AMENDMENTS TO THE DRAWINGS

Adalbert MATYKO et al. US Serial No. 10/553,059 July 6, 2007

FIG. 6

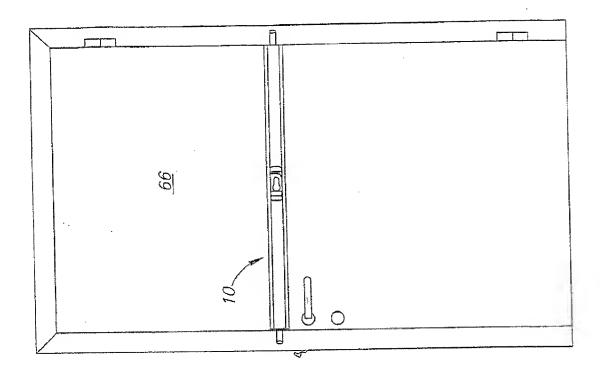
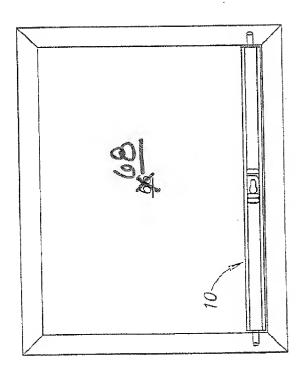
presented drawing sheets. The attached sheets of drawings includes an amended Figure 6

in which reference numeral 66 (left hand side) has been changed to 68, as suggested in

Fig. 6 of the drawings stands objected because reference character 66 on the window should be 68. The drawing has been accordingly corrected to overcome this objection.

the Action. An annotated Figure 6 showing the amendment is attached.
